## ADDENDUM #2

TO: Holders of Request for Bids # '15/20/B CIP # 507N – Genoveva Chavez  
Community Center (GCCC) Natatorium Dehumidification System Remodeling

FROM: City of Santa Fe Public Works Department, Facilities Division

**E-101**  
of

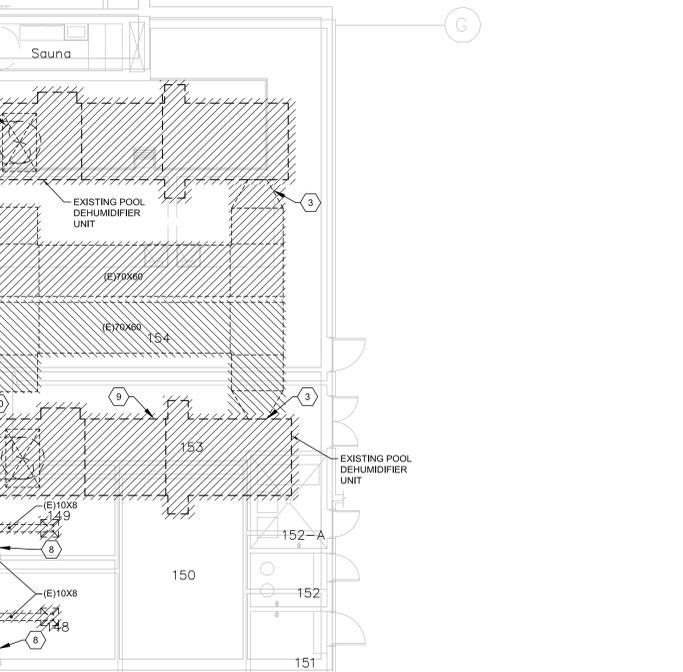
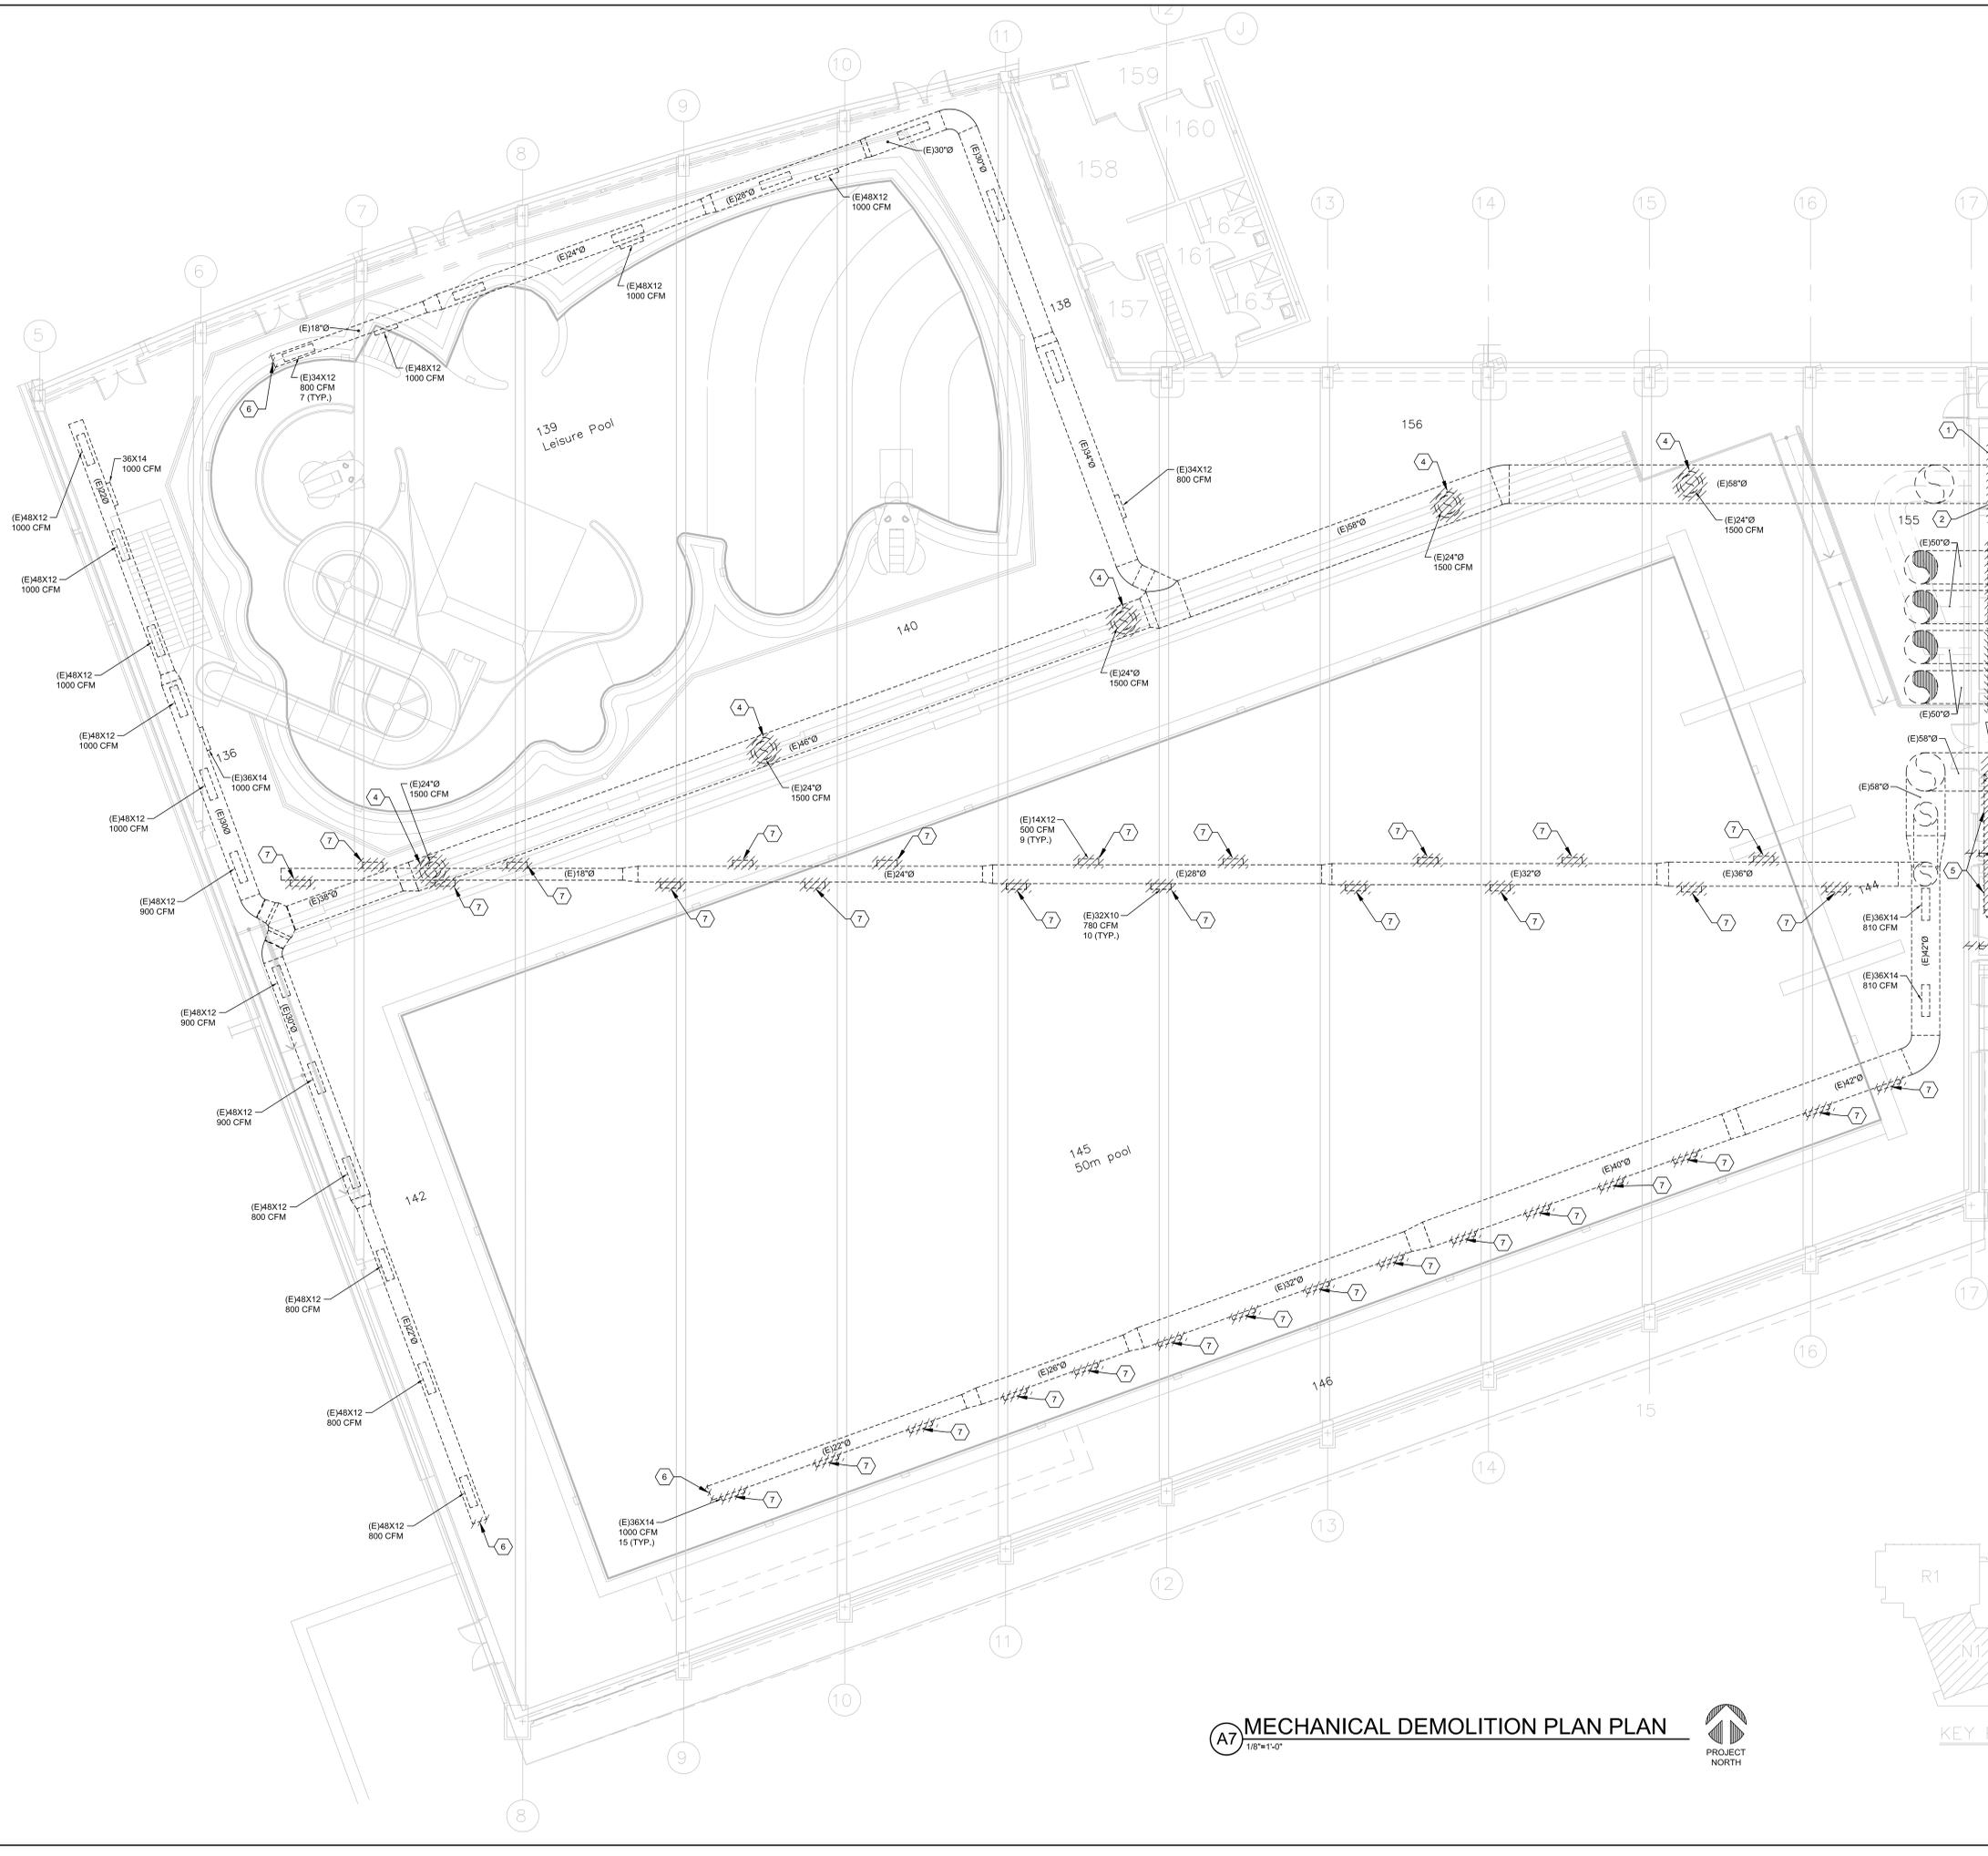
- 8) TRG to verify that new disconnect switch is located on unit and note to remove conduit back as required to reroute power up high along wall to avoid new ductwork and equipment.  
This has already been addressed on Keynote 17 /sheet E-101. All conduit and conductor are to be removed back to source.

Sheet E-101: Revised Keynote Number 1 to read "Coordinate new conduit routing to avoid Mechanical equipment and ductwork."
- 9) TRG will update roof curb detail on sheet M-601.

1. PROVIDE AND INSTALL A FUSIBLE DISCONNECT SWITCH, 400 AMP, 3-POLE, 800 VOLT, SN AND GROUND LUG, RAINTIGHT ENCLOSURE. PROVIDE WITH 225 AMP FUSES, 4#40 AND 1#4 GROUND IN 2 1/2" CONDUIT. COORDINATE NEW CONDUIT ROUTING TO AVOID MECHANICAL EQUIPMENT AND DUCTWORK.

M-102

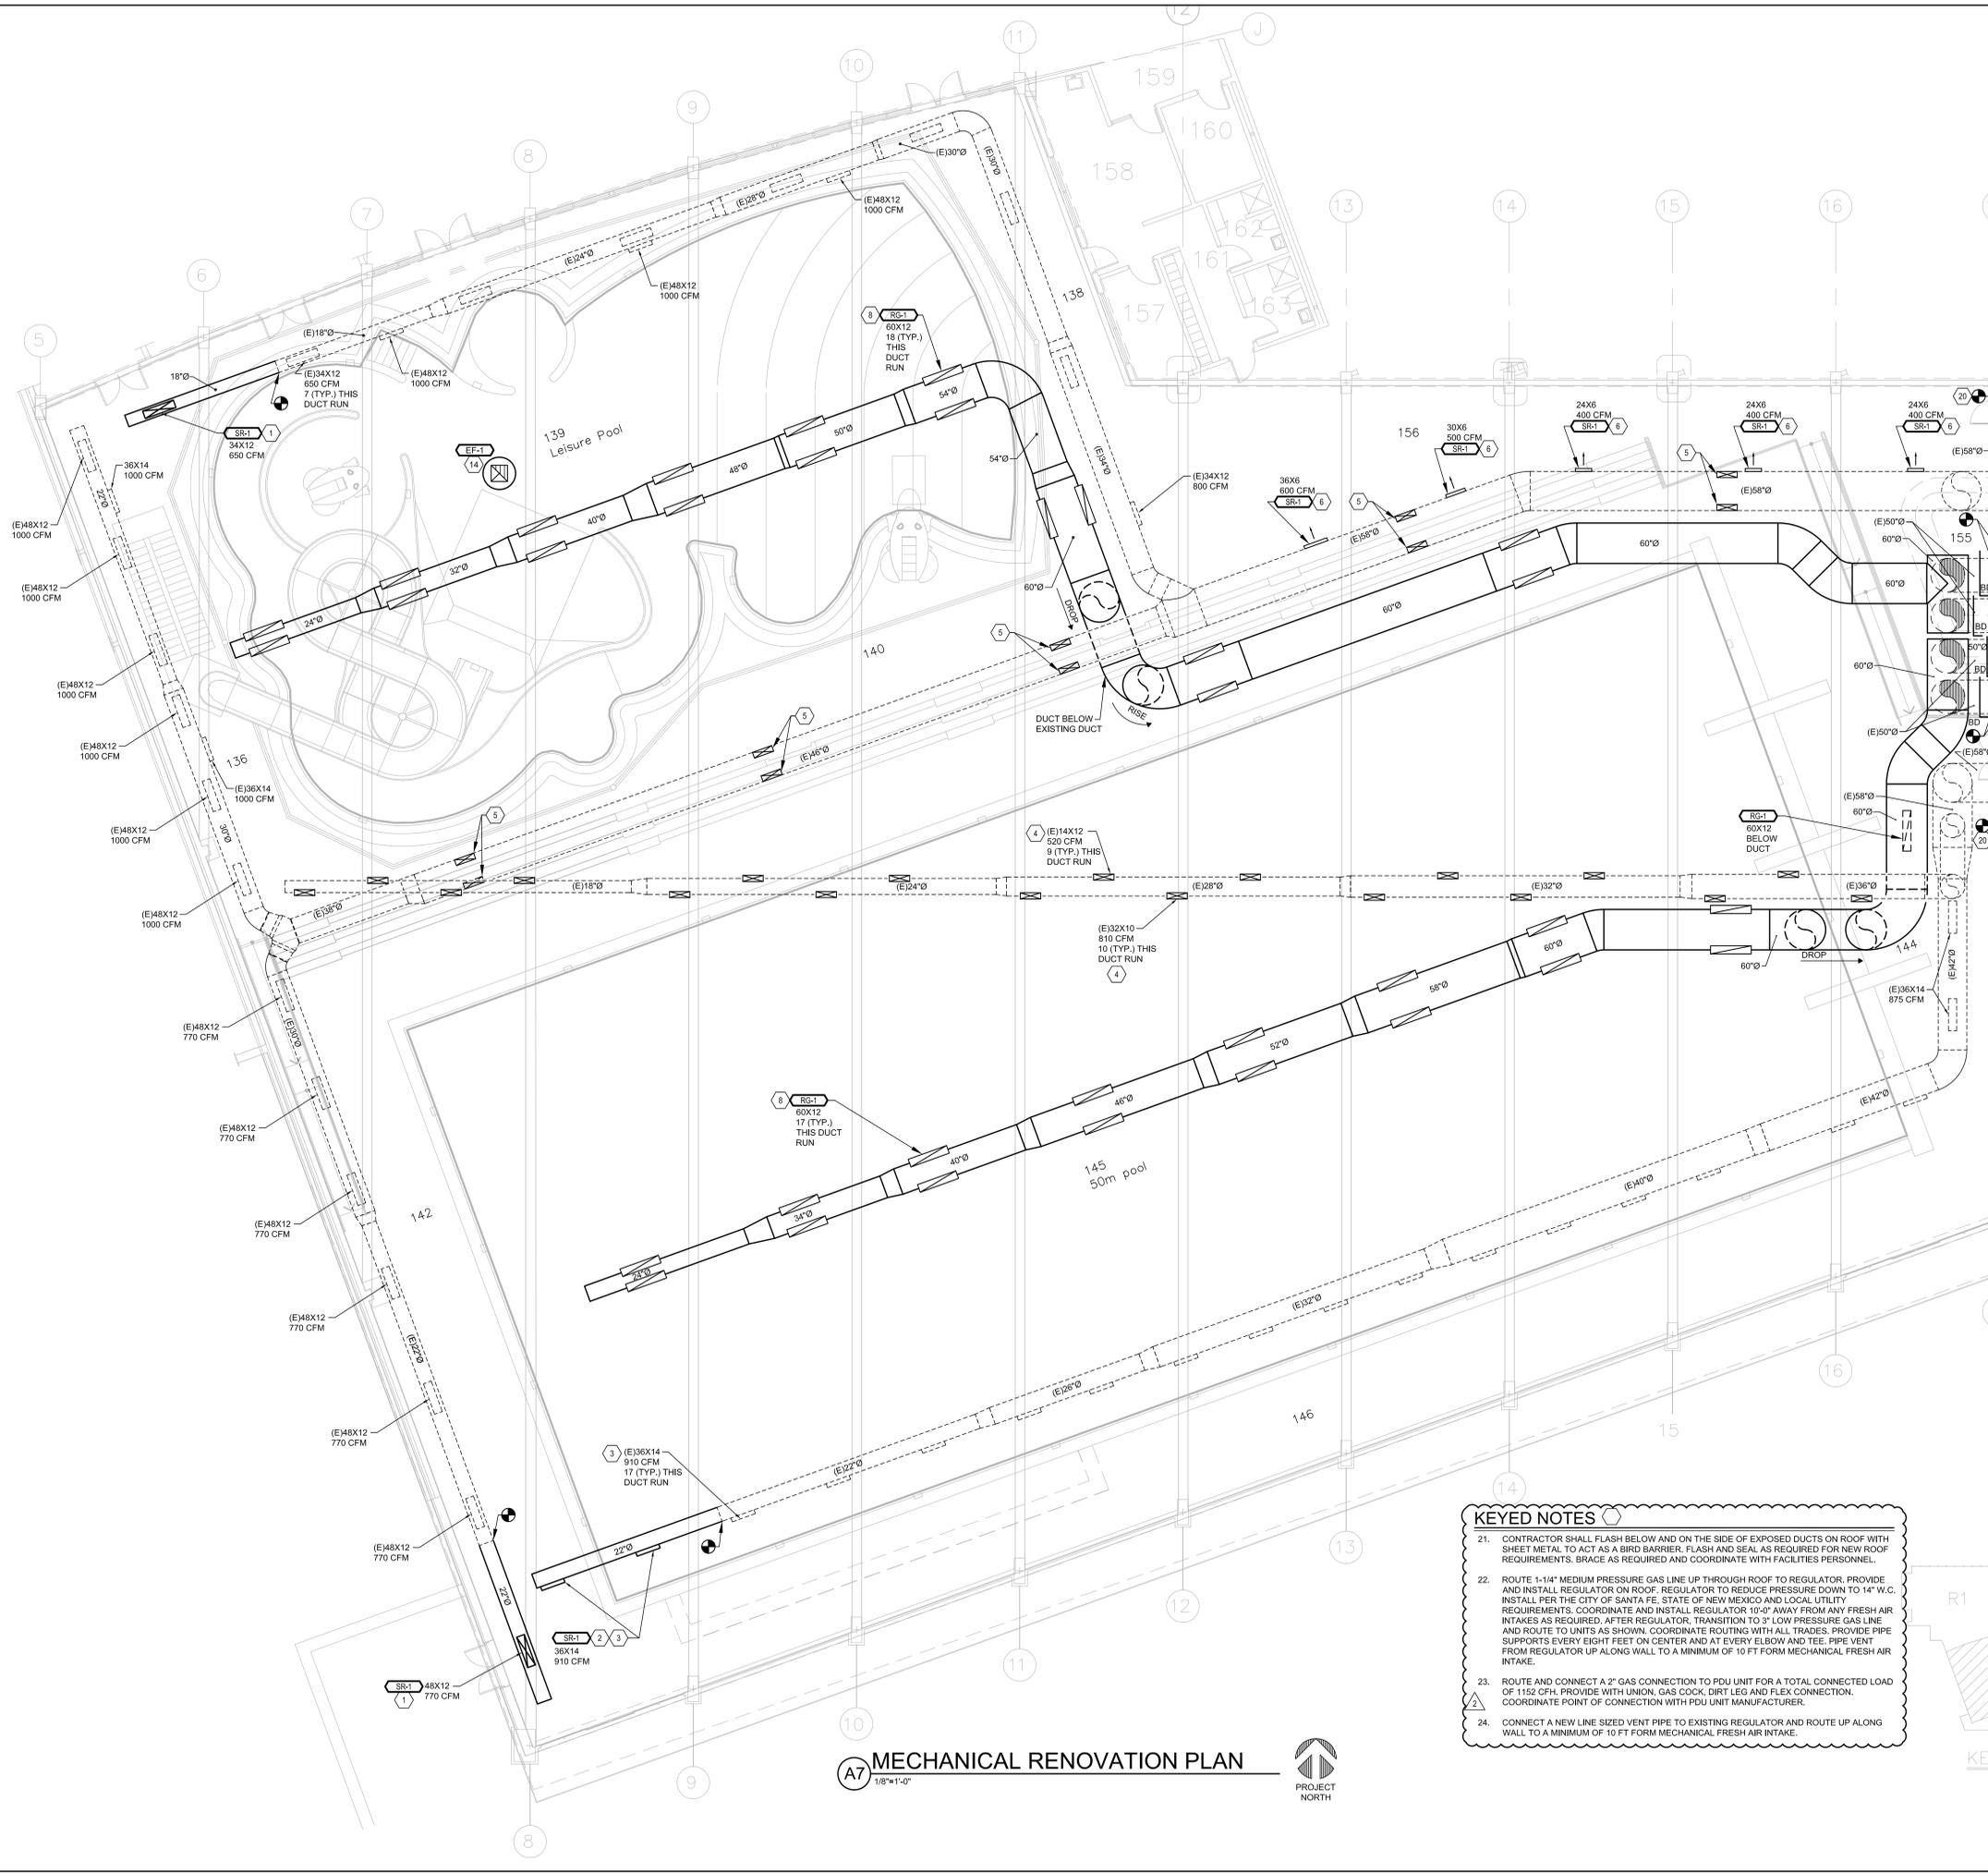
- 7) TRG will update the construction drawings to reflect the platform configuration.  
Sheet M-102: Mechanical Renovation Plan has been revised to show and reflect the platform.

- 11) TRG to note "Contractor shall flash below and on the side of exposed ducts on roof with sheet metal to act as a bird screen. Brace as required and coordinate with facilities personal."

Sheet M-102: Keynote 21 has been added to plan to read "CONTRACTOR SHALL FLASH BELOW AND ON THE SIDE OF EXPOSED DUCTS ON ROOF WITH SHEET METAL TO ACT AS A BIRD BARRIER. FLASH AND SEAL AS REQUIRED FOR NEW ROOF REQUIREMENTS. BRACE AS REQUIRED AND COORDINATE WITH FACILITIES PERSONNEL."

Sheet M-102: Revised Keynote 17 to read: "DROP 1-1/4" MEDIUM PRESSURE GAS LINE DOWN THRU ROOF AND ROUTE AND CONNECT TO EXISTING MEDIUM PRESSURE GAS LINE OF SAME SIZE OR LARGER. FIELD VERIFY EXISTING POINT OF CONNECTION WITH FACILITIES PERSONAL. READJUST OR REPLACE EXISTING METER/REGULATOR UP STREAM FOR AN ADDITIONAL LOAD OF 2304 MBH. COORDINATE WITH GAS COMPANY AND FACILITY PERSONNEL TO DETERMINE TOTAL GAS LOAD OF BUILDING AND CONNECTION REQUIREMENTS. FIELD VERIFY EXACT METER/REGULATOR LOCATION. FOR PURPOSE OF ISOLATION AND SAFETY. VERIFY THAT AN ADDITIONAL FULL BORE GAS SHUTOFF IS INSTALLED DOWNSTREAM OF THE SERVING SUPPLIER GAS METER PRIOR TO ANY DISTRIBUTION OF GAS INTO THE PIPING SYSTEM. INSTALL IF REQUIRED. REGULATOR IS ESTIMATED TO BE 200'-0"+/- FROM REGULATOR. IF THERE IS ANY DISCREPANCY IN THE DISTANCE OF PIPING CONTACT THE ENGINEER FOR CLARIFICATION. ROUTE GAS LINE WITH PIPE SUPPORTS EVERY EIGHT FEET ON CENTER AND AT EVERY ELBOW AND TEE. OFFSET 12" FOR EVERY 100'-0" OF STRAIGHT RUN OF GAS PIPE AS REQUIRED PER CODE."

Sheet M-102: Added Keynote 22 to read: "ROUTE 1-1/4" MEDIUM PRESSURE GAS LINE UP THROUGH ROOF TO REGULATOR. PROVIDE AND INSTALL REGULATOR ON ROOF. REGULATOR TO REDUCE PRESSURE DOWN TO 14" W.C. INSTALL PER THE CITY OF SANTA FE, STATE OF NEW MEXICO AND LOCAL UTILITY REQUIREMENTS. COORDINATE AND INSTALL REGULATOR 10'-0" AWAY FROM

ANY FRESH AIR INTAKES AS REQUIRED. AFTER REGULATOR, TRANSITION TO 3" LOW PRESSURE GAS LINE AND ROUTE TO UNITS AS SHOWN. COORDINATE ROUTING WITH ALL TRADES. PROVIDE PIPE SUPPORTS EVERY EIGHT FEET ON CENTER AND AT EVERY ELBOW AND TEE. PIPE VENT FROM REGULATOR UP ALONG WALL TO A MINIMUM OF 10 FT FORM MECHANICAL FRESH AIR INTAKE."

Sheet M-102: Added Keynote 23 to read: "ROUTE AND CONNECT A 2" GAS CONNECTION TO PDU UNIT FOR A TOTAL CONNECTED LOAD OF 1152 CFH. PROVIDE WITH UNION, GAS COCK, DIRT LEG AND FLEX CONNECTION. COORDINATE POINT OF CONNECTION WITH PDU UNIT MANUFACTURER."

Sheet M-102: Added Keynote 24 to read: "CONNECT A NEW LINE SIZED VENT PIPE TO EXISTING REGULATOR AND ROUTE UP ALONG WALL TO A MINIMUM OF 10 FT FORM MECHANICAL FRESH AIR INTAKE."

17. DROP 1-1/4" MEDIUM PRESSURE GAS LINE DOWN THRU ROOF AND ROUTE AND CONNECT TO EXISTING MEDIUM PRESSURE GAS LINE OF SAME SIZE OR LARGER. FIELD VERIFY EXISTING POINT OF CONNECTION WITH FACILITIES PERSONNEL. READJUST OR REPLACE EXISTING METER/REGULATOR UP STREAM FOR AN ADDITIONAL LOAD OF 2304 MBH. COORDINATE WITH GAS COMPANY AND FACILITY PERSONNEL TO DETERMINE TOTAL GAS LOAD OF BUILDING AND CONNECTION REQUIREMENTS. FIELD VERIFY EXACT METER/REGULATOR LOCATION. FOR PURPOSE OF ISOLATION AND SAFETY, VERIFY THAT AN ADDITIONAL FULL SIZE GAS SHUTOFF IS INSTALLED DOWNSTREAM OF THE SERVING SUPPLIER GAS METER PRIOR TO ANY DISTRIBUTION OF GAS INTO THE PIPING SYSTEM. INSTALL IF REQUIRED. REGULATOR IS ESTIMATED TO BE 200'-0" FROM REGULATOR. IF THERE IS ANY DISCREPANCY IN THE DISTANCE OF PIPING CONTACT THE ENGINEER FOR CLARIFICATION. ROUTE GAS LINE WITH PIPE SUPPORTS EVERY EIGHT FEET ON CENTER AND AT EVERY ELBOW AND TEE. OFFSET 12" FOR EVERY 100'-0" OF STRAIGHT RUN OF GAS PIPE AS REQUIRED PER CODE.

20. TRANSITION DUCT AS REQUIRED AND CONNECT TO NEW UNIT. PROVIDE WITH FLEX CONNECTION TO UNIT.
21. CONTRACTOR SHALL FLASH BELOW AND ON THE SIDE OF EXPOSED DUCTS ON ROOF WITH SHEET METAL TO ACT AS A BIRD BARRIER. FLASH AND SEAL AS REQUIRED FOR NEW ROOF REQUIREMENTS. BRACE AS REQUIRED AND COORDINATE WITH FACILITIES PERSONNEL.

22. ROUTE 1-1/4" MEDIUM PRESSURE GAS LINE UP THROUGH ROOF TO REGULATOR. PROVIDE AND INSTALL REGULATOR ON ROOF. REGULATOR TO REDUCE PRESSURE DOWN TO 14" W.C. INSTALL PER THE CITY OF SANTA FE, STATE OF NEW MEXICO AND LOCAL UTILITY REQUIREMENTS. COORDINATE AND INSTALL REGULATOR 10'-0" AWAY FROM ANY FRESH AIR INTAKES AS REQUIRED. AFTER REGULATOR, TRANSITION TO 3" LOW PRESSURE GAS LINE AND ROUTE TO UNITS AS SHOWN. COORDINATE ROUTING WITH ALL TRADES. PROVIDE PIPE SUPPORTS EVERY EIGHT FEET ON CENTER AND AT EVERY ELBOW AND TEE. PIPE VENT FROM REGULATOR UP ALONG WALL TO A MINIMUM OF 10 FT FORM MECHANICAL FRESH AIR INTAKE.

23. ROUTE AND CONNECT A 2" GAS CONNECTION TO PDU UNIT FOR A TOTAL CONNECTED LOAD OF 1152 CFM. PROVIDE WITH UNION, GAS COCK, DIRT LEG AND FLEX CONNECTION. COORDINATE POINT OF CONNECTION WITH PDU UNIT MANUFACTURER.

24. CONNECT A NEW LINE SIZED VENT PIPE TO EXISTING REGULATOR AND ROUTE UP ALONG WALL TO A MINIMUM OF 10 FT FORM MECHANICAL FRESH AIR INTAKE.
25. INSTALL NEW DEHUMIDIFICATION UNIT ON ROOF WITH INSULATED ALUMINUM LINED ROOF CURB PER MANUFACTURERS REQUIREMENTS. ROOF CURB SHALL ACT AS RETURN AIR PLENUM AND SHALL BE SUPPLIED AS A 3-PIECE SYSTEM. IT SHALL INCLUDE 2 UNIT CURBS WITH VIBRATION AND SOUND PACKAGES AND ONE INTERCONNECTING CURB. CONTRACTOR SHALL CONNECT AND INSTALL TOGETHER AND SEAL WEATHER TIGHT. COORDINATE LOCATION WITH STRUCTURAL REINFORCEMENT. MAKE ALL REQUIRED CONNECTIONS AS REQUIRED FOR A COMPLETE OPERATING SYSTEM PER MANUFACTURERS REQUIREMENTS. EACH UNIT SHALL INCLUDE A PIP WALKWAY SYSTEM INSTALLED ON ROOF. COORDINATE WITH SUPPLIER FOR COMPLETE SPECIFICATION AND REQUIREMENTS.

B5 NO SCALE

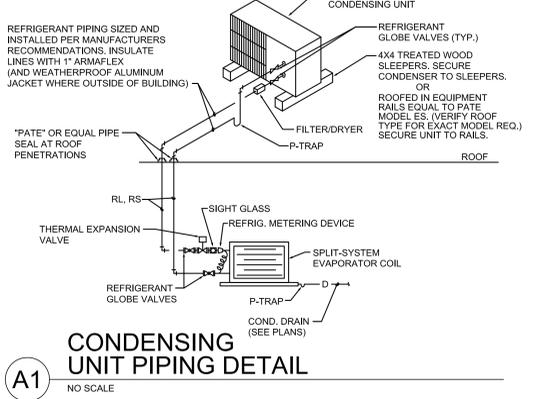
Sheet M-601: Revised Detail B5/M-601 - Pool Dehumidifier Unit Roof Curb Detail
